Schedule A

Modifications to Part III of OPA 149

OFFICIAL PLAN AMENDMENT No. 149
TOWN OF MARKHAM OFFICIAL PLAN (REVISED 1987) AS AMENDED
SCHEDULE BB - TRANSPORTATION

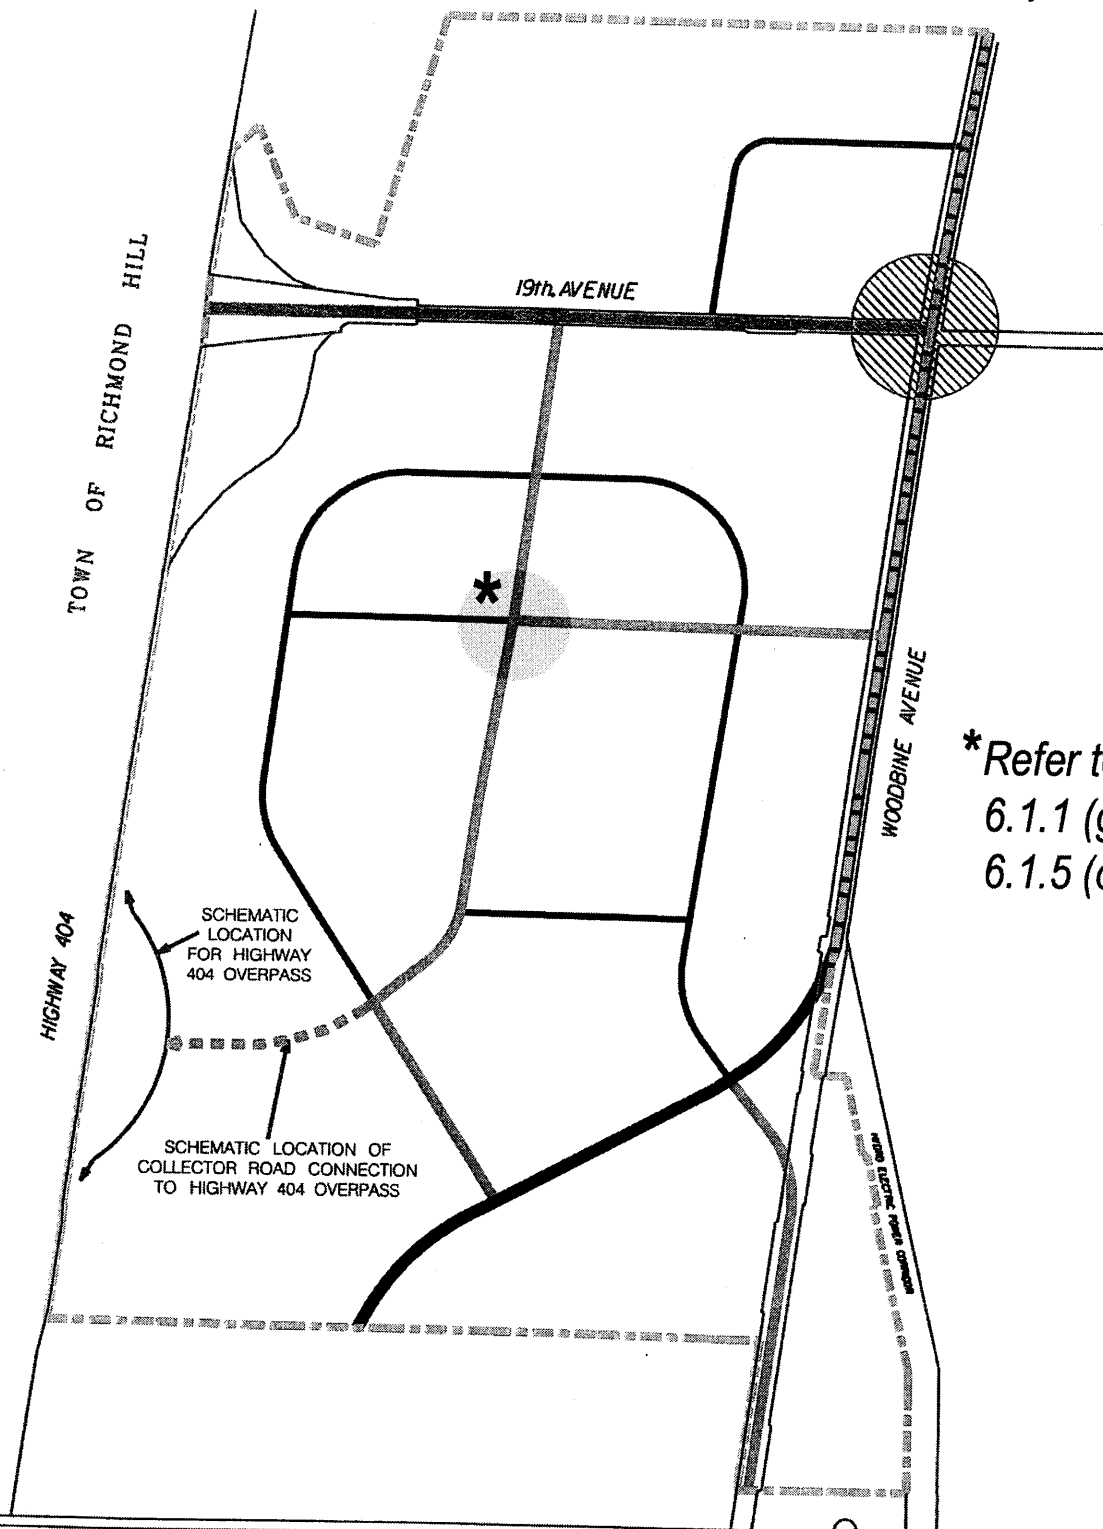
- 8. Schedule BB – Transportation, modified to include reference to policies in the secondary plan as shown on the attached schedule.

*Refer to policies
6.1.1 (g)
6.1.5 (c)
